Re: Monterey Peninsula Water Supply Project: Responses to (1) Appeals of the Planning Commission's Approval of the Project's Desalination Plant (PLN150889) and Carmel Valley Pump Station (PLN150653) and (2) Comment Letters Submitted to the Planning Commission

This Attachment A responds to three appeals submitted to the Board of Supervisors: MCWD's appeals of Planning Commission Resolutions PLN150653 and PLN150889 ("MCWD Pump Station Appeal" and "MCWD Desal Plant Appeal," respectively), and PWN's appeal of Planning Commission Resolution PLN150889 ("PWN Appeal"). The Attachment also responds to comments submitted to the Planning Commission at or before its April 24, 2019, hearing by MCWD ("MCWD April 23, 2019 Letter"), the City of Marina ("Marina April 23, 2019 Letter"), and California Unions for Reliable Energy ("CURE April 23, 2019 Letter").

Annual Precipitation and Cumulative Departure from Mean Annual Precipitation in Marina, CA (1961-2018)

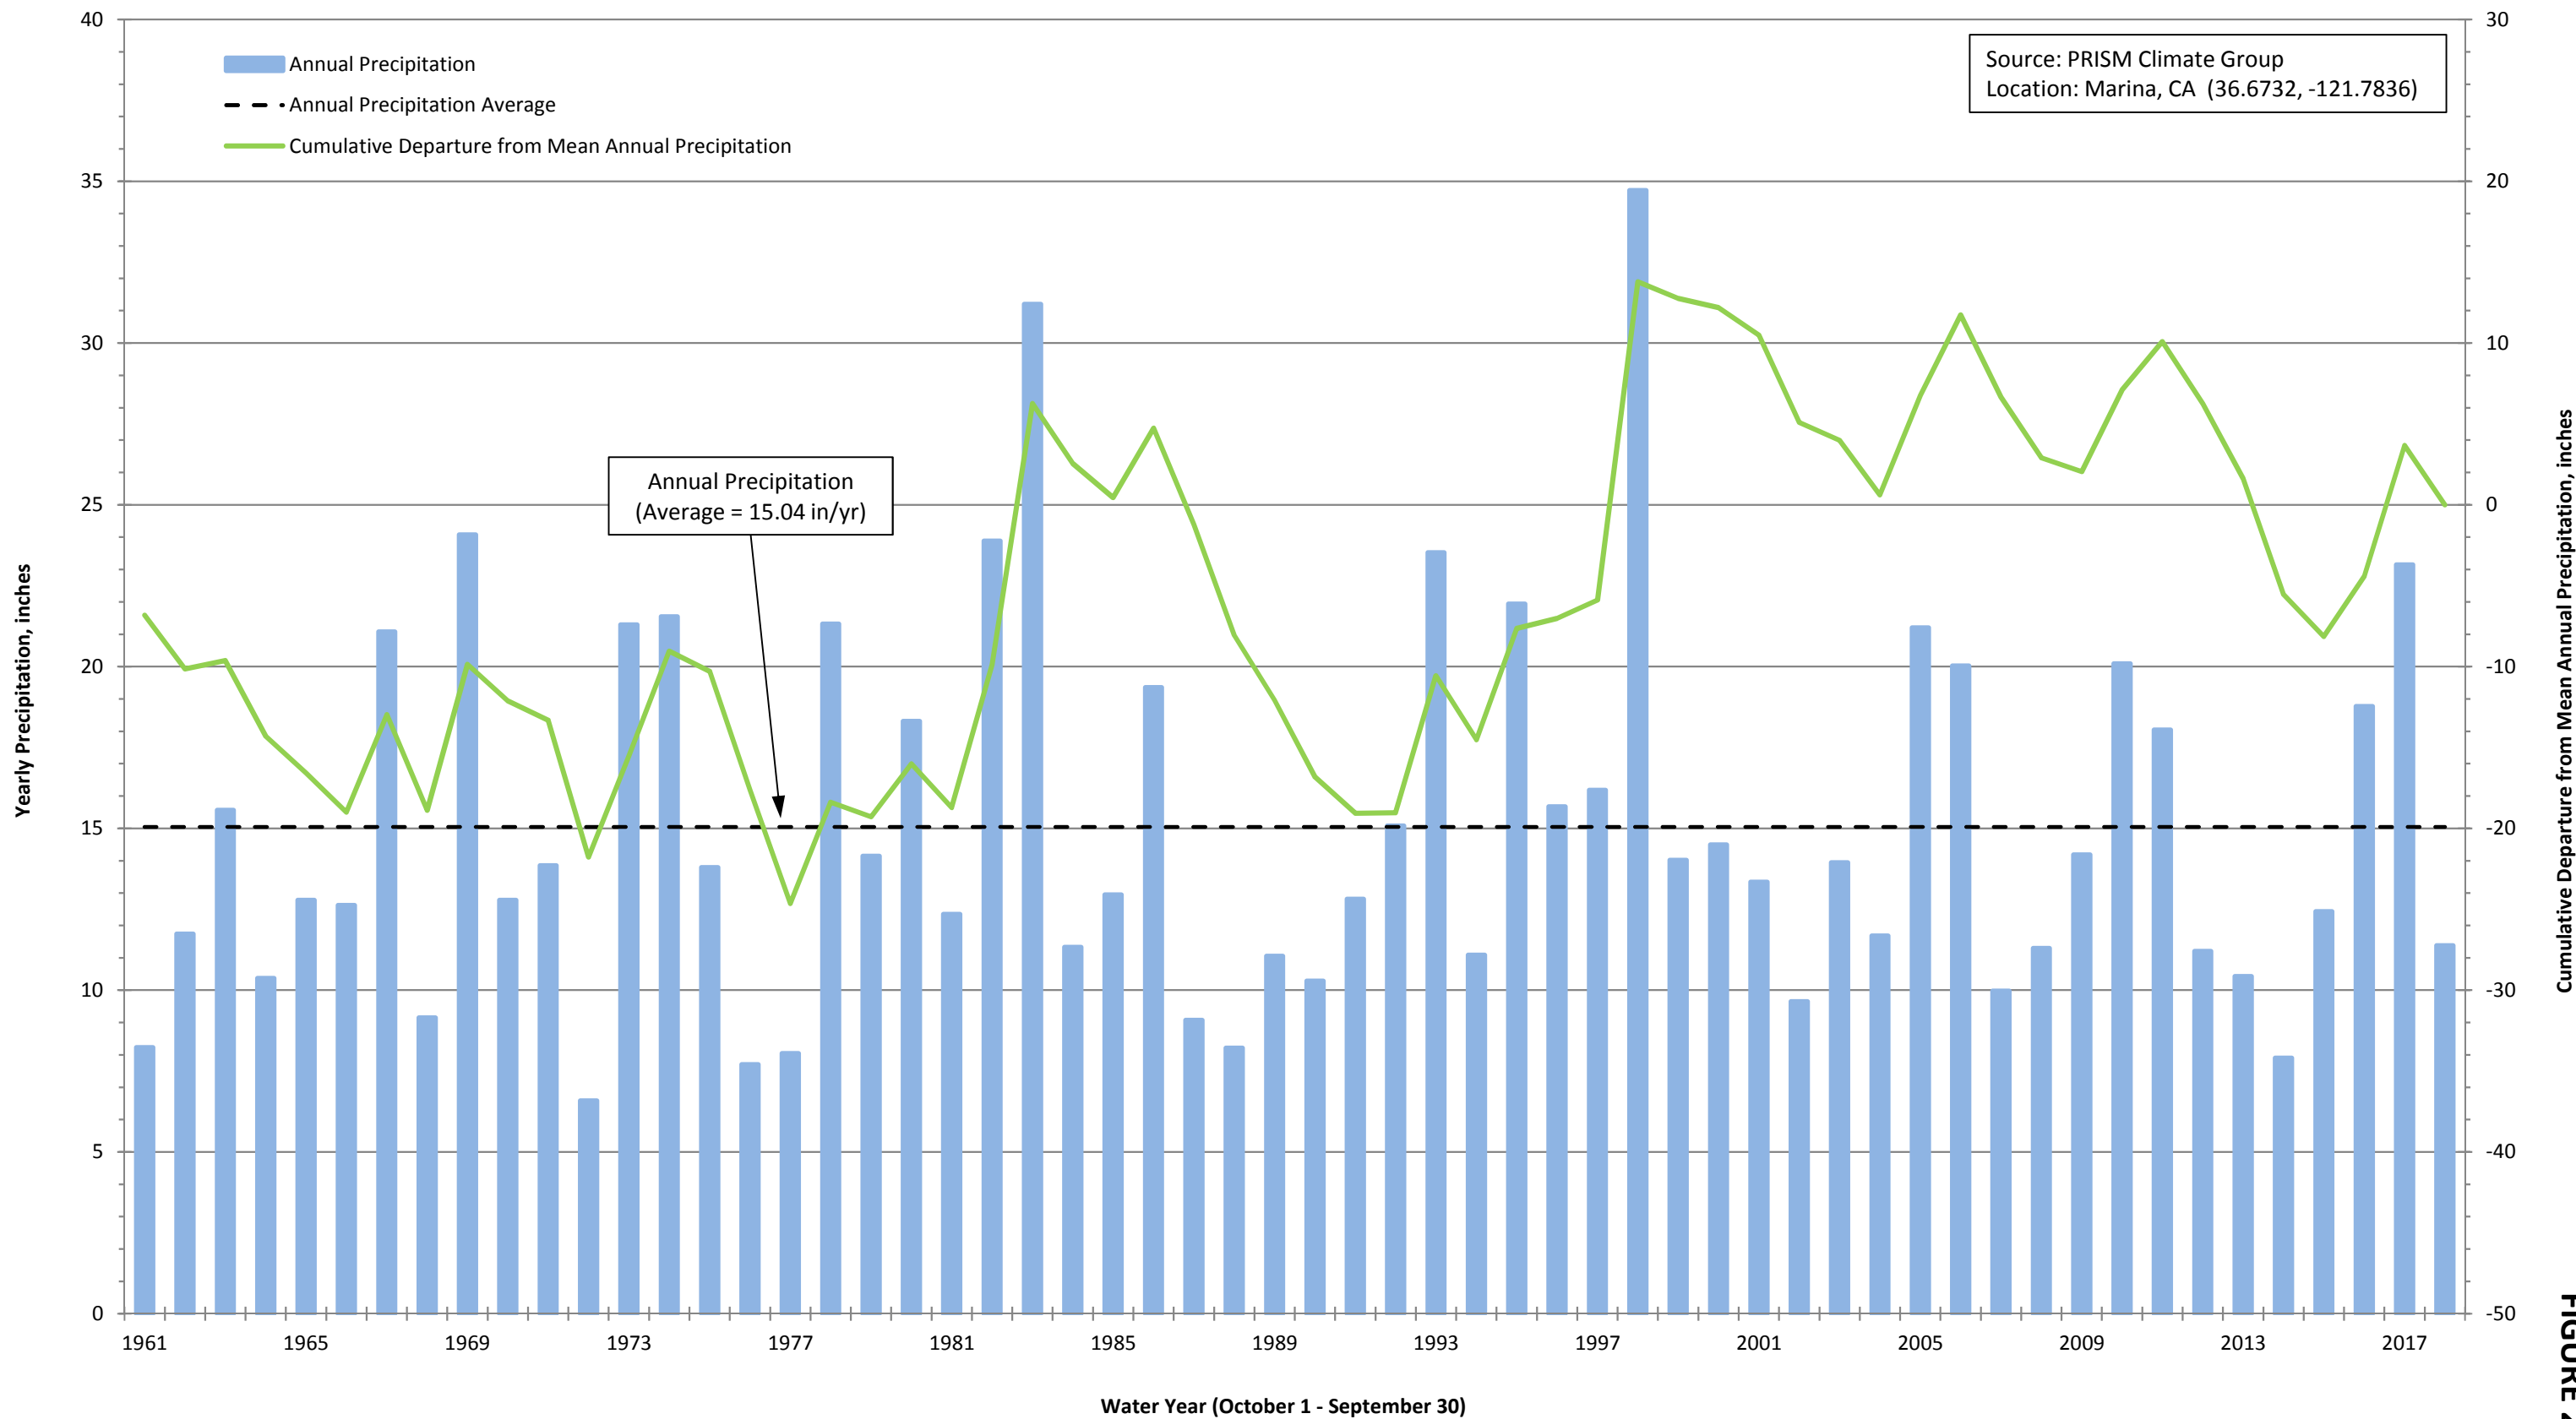
50. It is unclear what HGC is referring to in Figure 8 and associated discussion on page 20. However, it is quite clear from the figure that a slight reduction in test slant well EC corresponds to heavy seasonal rainfall that occurred in late 2016/early 2017. HGC tries to argue otherwise but data do not support HGC’s argument. Furthermore, once the rainfall from the record wet year enters the aquifer system, there will be a time lag for the water to be removed via test slant well pumping, so it is not surprising at all to see a residual slight reduction in EC following the record wet-year rainy season.
